**Subject: Request for Amendment to Reclamation Plan Approval F20169958
to the Tailings Storage Facility Final Beaching Height**

RE: Red Dog Mine Reclamation Closure Amendment Request for the Tailings Storage Facility Final Beaching Height

RED DOG TAILINGS STORAGE FACILITY – TAILINGS MAIN DAM BEACH CONFIGURATION AT CLOSURE

Main Dam Beach, Typical Section

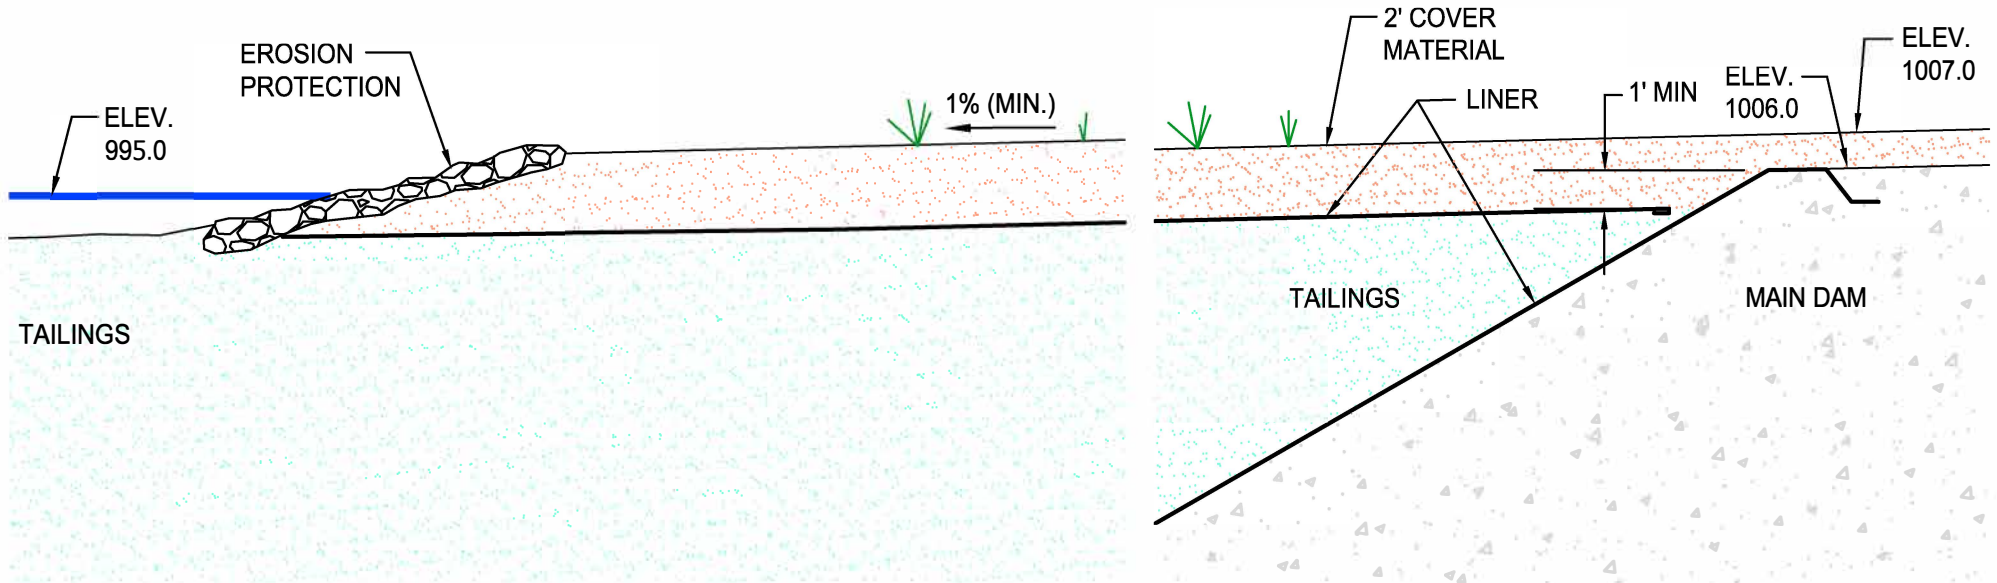
The proposed closure section provided by Teck for Golder’s review is shown in Attachment 1, and allows for a maximum struck tailings elevation at closure of 993 feet, and a minimum normal pond elevation of 995 feet to maintain 2 feet of water cover over the tailings. Table 1 presents the elevations resulting from a hydrologic/hydraulic assessment carried out by Golder¹. The assessment provides the derivation for the maximum struck tailings elevation, which match those shown in Attachment 1.

Seepage modeling and operational experience have shown that a tailings beach established against the embankment significantly reduces seepage reporting to the underdrain system at the TMD. Teck has established in their closure plan a criterion that a 600-foot-wide beach be established against the TMD as shown in Attachment 1. Golder, as Engineer of Record (EOR) of the TMD, has reviewed this configuration, has assessed that it will not reduce embankment stability, and agrees with the concept, including maintaining the 600-foot-wide beach against the embankment.

As shown in Attachment 1, the closure configuration allows for 2 feet of cover material placed over the 600-foot-wide beach, with a geomembrane liner separating the cover material from the tailings. One foot of beach freeboard is provided at the embankment, resulting in one foot of cover material overlying the upstream embankment crest. Although the slope of the erosion protection is not shown, Golder anticipates that if it is steeper than the tailings beach slope it would reduce the height of the wave runup.
